**SOILS AND GEOLOGY STUDY
MONUMENT RIDGE EAST – FILING NO. 1
MONUMENT HILL ROAD AND PALMER DIVIDE ROAD
EL PASO COUNTY, COLORADO**

Re: Response to Review Comments
Monument Ridge East
Monument Hill Road and Palmer Divide Road
El Paso, Colorado
Entech Job No. 230248

EP-24-0077 Monument Ridge East
N½ Section 2, T11S, R67W, 6th Meridian
39.1284, -104.8624
File Number: SP241
Preliminary plan to create 342 residential lots on 63 acres.

psw - potentially shallow groundwater area
sw - seasonally shallow groundwater area
w - standing water/wetlands

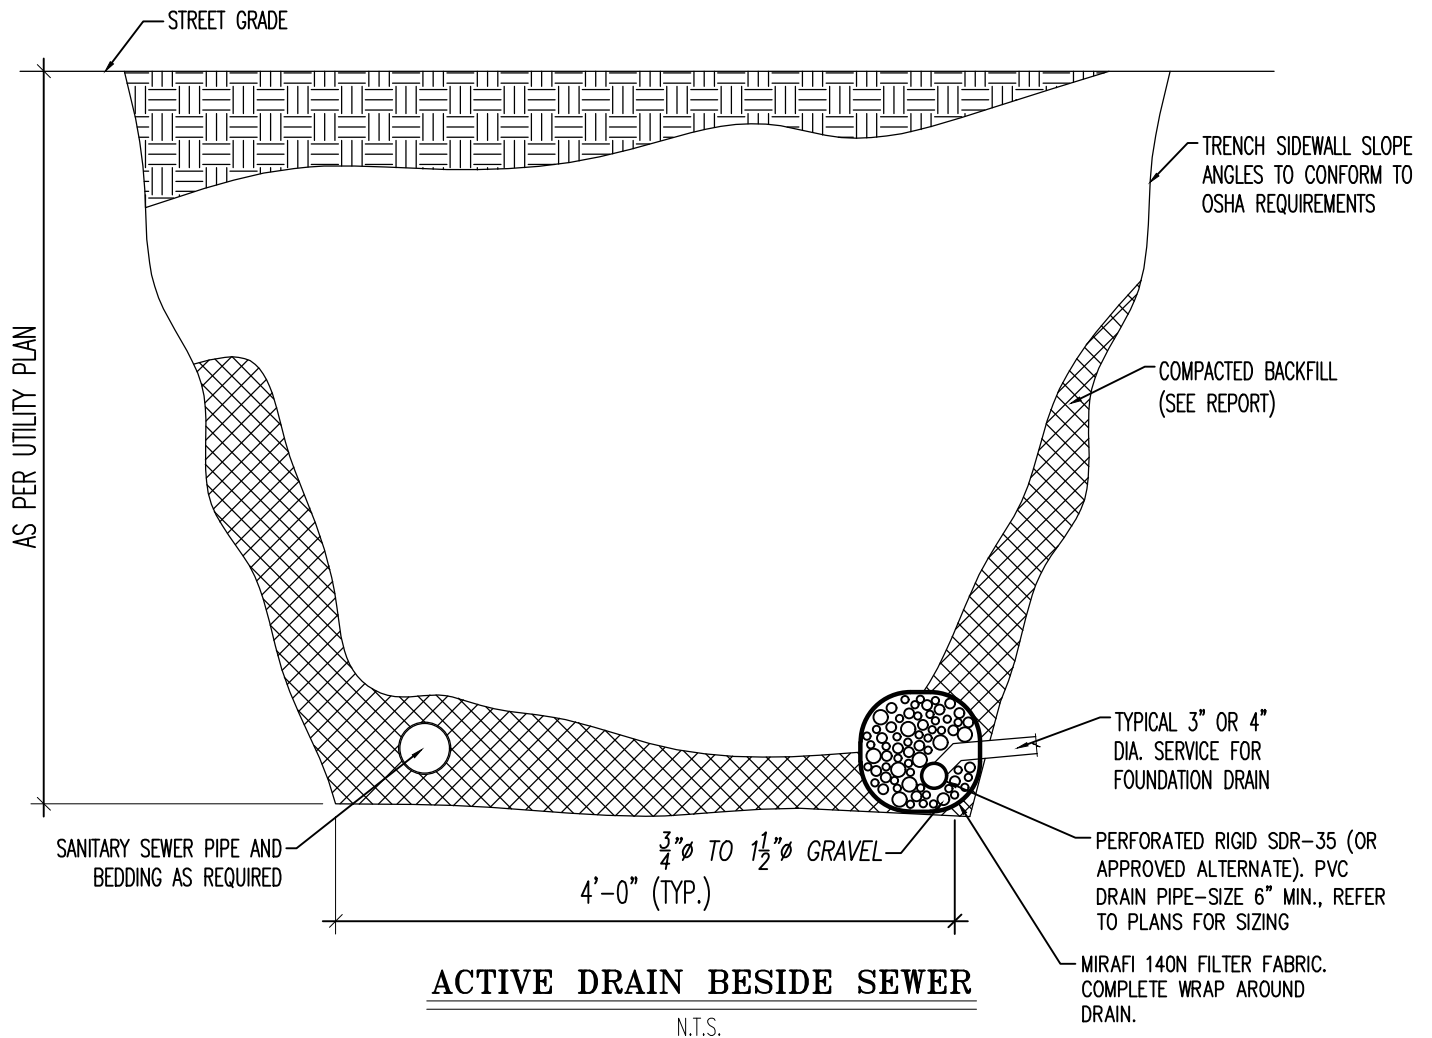
1. Entech encountered groundwater at depths ranging from 1 to 10 feet during drilling. However, figure 7 of their report fails to depict this shallow groundwater in the relevant areas. Test Boring No. 3, which includes groundwater at 1 foot, is mapped as Colluvium and Dawson Formation without shallow groundwater. It is imperative that Figure 7 is revised to reflect the geologic hazards and constraints.

4. A geologic hazard note is not included in the preliminary plan drawings. CGS recommends updating Figure 7 of Entech’s report and adding a note to the preliminary plan/plat listing the geologic hazards and constraints, along with mitigation measures.

5. Wetlands (Freshwater Emergent/Freshwater Forested/Shrub Wetland) are located within the site. However, these areas do not appear to be portrayed correctly in Figure 7 of Entech’s report. These areas are associated with standing water; lots should not be located within these areas, a setback should be established, and these areas should be designated as “No Build Areas”. Setbacks and no build areas should be noted on the plans.

Entech Response to Comment 1: The Geology/Engineering Geology Map has been updated and is included with the revised report.

Entech Response to Comment 4: Figure 7 has been updated, and a geologic hazard note provided for the preliminary plan/plat.

Entech Response to Comment 5: Entech is in agreement that lots should not be located within the delineated jurisdictional wetlands located in the northern and northwestern portions of the site. The jurisdictional wetlands lie within no-build areas and will be avoided by the development.
